**NUMBER:** 23-011-14 REV. A

Left Rear Sliding Door Weatherstrip Seal Sticks Out At Bottom Of C-Pillar Door Opening

This bulletin involves replacing the left rear C-pillar cut line sliding door seal.

2014                      RT                                      Caravan / Town & Country

**Fig. 1 Symptom Condition Area Of Concern**

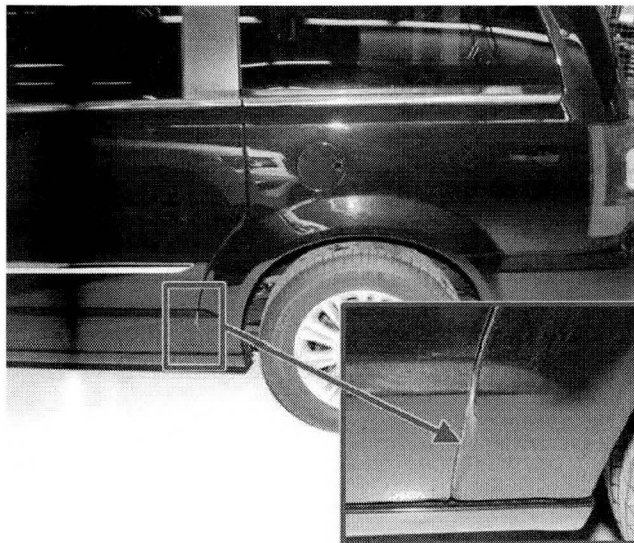
Some vehicles may have a left rear sliding door weatherstrip seal that sticks out along the C-pillar side of the door opening as shown in (Fig. 1).

1. **\*\*Is the left rear sliding door weatherstrip seal sticking out along the C-pillar side of the door opening as shown in (Fig. 1)?**
  - a. YES >>> Continue with Step #2.
  - b. No >>> No further action is required. This bulletin does not apply.\*\*

**Fig. 2 Door Weatherstrip Seal Replacement**

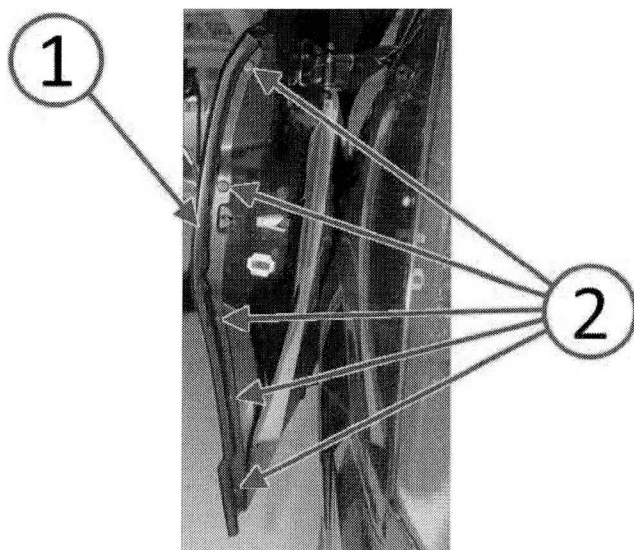
2. Replace the weatherstrip seal on the left rear sliding door with the seal specified in the PARTS REQUIRED section of this bulletin (Fig. 2).

Qty.	Part No.	Description
1	68078281AC	SEAL, Rear Door, C-Pillar Cut Line, Left

**Fig. 3 Symptom Condition Corrected**

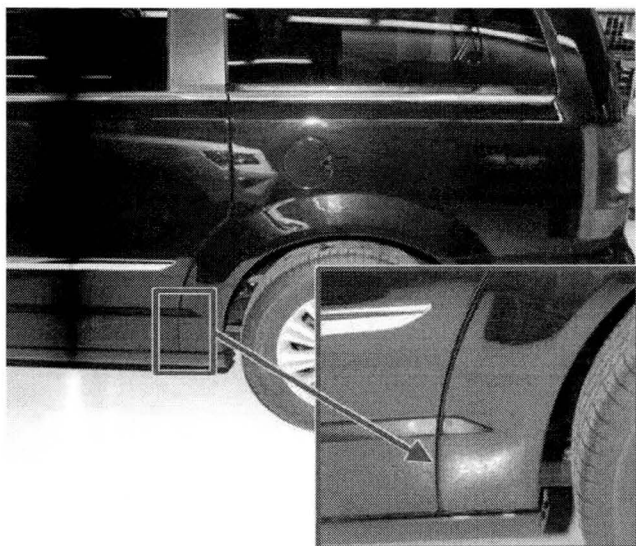
3. Verify that the symptom/condition has been corrected as shown in (Fig. 3).
